CERTIFICATE OF APPROPRIATENESS

Applicant: Nick Eronko of Bungalow Revival for Lauren Colby, owner

Property: 209 1/2 East Woodland Street, Tract 10C, Block 29, Grota Home Subdivision. The property includes a historic 864 square foot, one-story wood frame single-family residence situated on a 5,467 square foot (50' x 125') interior lot.

Proposal: Alteration – Addition

SOUTH ELEVATION – FRONT FACING EAST WOODLAND STREET

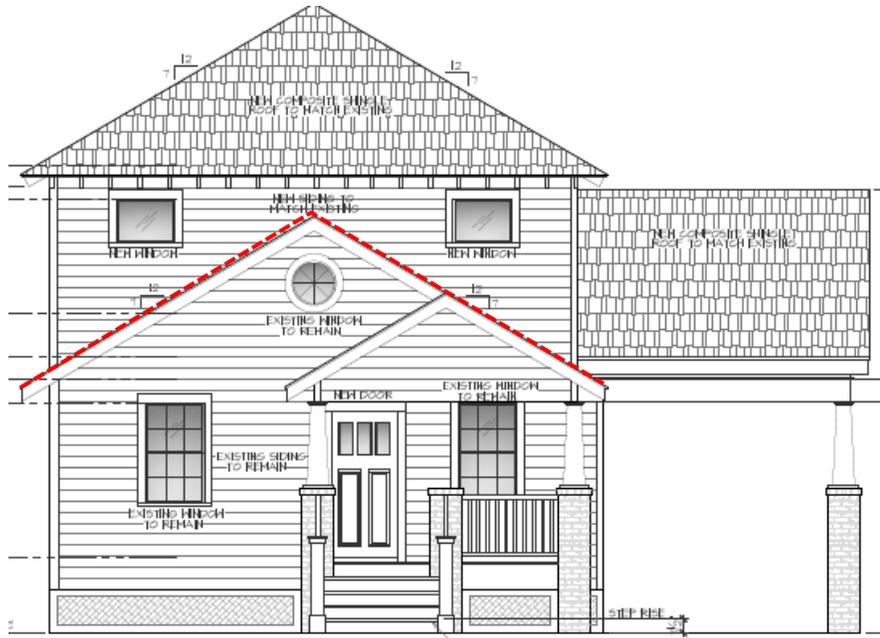
- (1) The proposed activity must retain and preserve the historical character of the property;
The two-story rear addition and lifting of the existing historic residence change the character of the structure a small one story bungalow to one that is taller and wider.

The proposed taller and wider two-story addition is of an incompatible scale compared to the existing historic one-story residence.

Section 1:12 pertains to the size. It specifies that an addition to the side of the house that is taller than the original house is an "Incompatible Change". The proposed side porte-cochere features a ridge height of 20', which is 2' 5" taller than the existing ridge height of the historic residence. This section also specifies that additions that "visually dominate" the original house as incompatible, showing an illustration of a front elevation of a two-story addition on a one story house as an example. The proposed addition visually dominates the original house as it is both taller and wider than the existing structure.

WEST SIDE ELEVATION

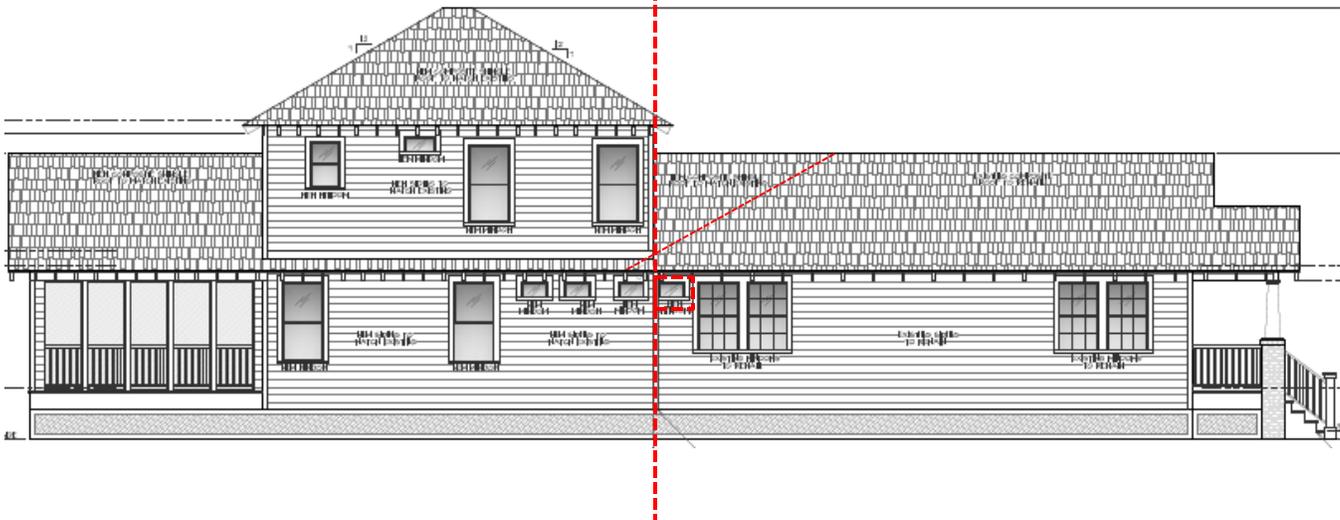
Side Elevation: Cut a 18" by 10" opening for a new single lite casement window in the rear of the west elevation of
(West) the existing structure. The two story addition will begin at the rear of the existing structure.

EAST SIDE ELEVATION

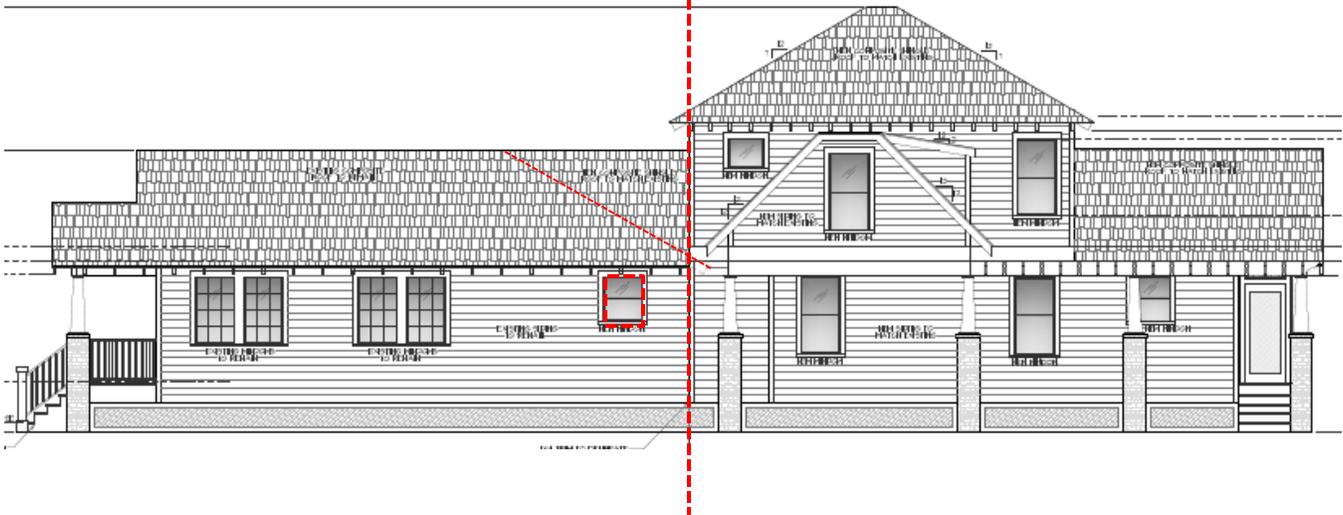
The proposed porte-cochere is not an appropriate exterior feature for this house or the Germantown Historic District. Historic porte-cocheres are not found on Contributing one-story bungalows within Germantown.

Side Elevation: Cut a 28" by 30" opening in the east side elevation to install a new 1-over-1 window. Remove a non-original window and cover the opening with siding. The addition will begin at the rear wall of the existing structure. The first 16' of porte-cochere will feature a side clipped gable and a ridge height of 20'. The remaining 23' will consist of a flat arbor structure.

FRONT PORCH

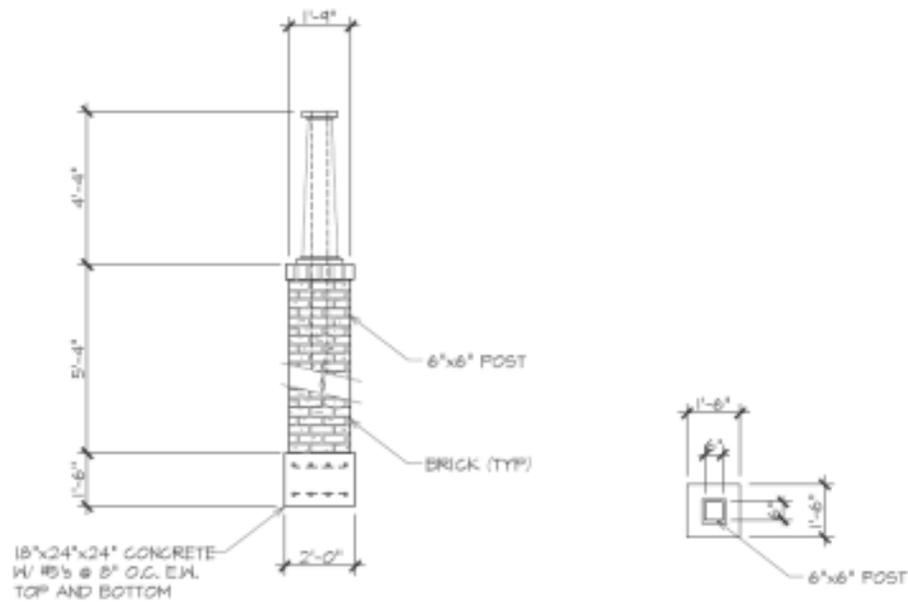
- Replacing the existing turned porch columns and recessed panel front door with tapered columns and a Craftsman style front door introduces architectural elements that are inconsistent with the house's existing character. The proposed porte-cochere is also inconsistent with the character of the existing structure.*

- Although not original to the structure, the existing recessed panel front door and turned porch columns are compatible with the existing structure's otherwise modest character. Replacing these features with 2' wide tapered columns with brick piers and a Craftsman style divided lite front door undermines the character of the property by adding elements that are larger, more decorative, and of a different architectural style than the historic structure.*

The proposed addition of 2' wide tapered columns on brick piers and a Craftsman style front door are incompatible with the modest character of the structure. No evidence has been submitted to indicate that the proposed Craftsman architectural features ever existed on this residence.

Section 1:20 pertains to front porches. It specifies replacing porch elements of one architectural style with another as an "Incompatible Change." It also states that adding porch elements that are not part of the house's original design is incompatible. The proposed alteration does not meet these requirements as it replaces turned porch columns with tapered columns with brick piers. The proposed columns are a feature associated with Craftsman style architecture, which is not the style of the existing structure.
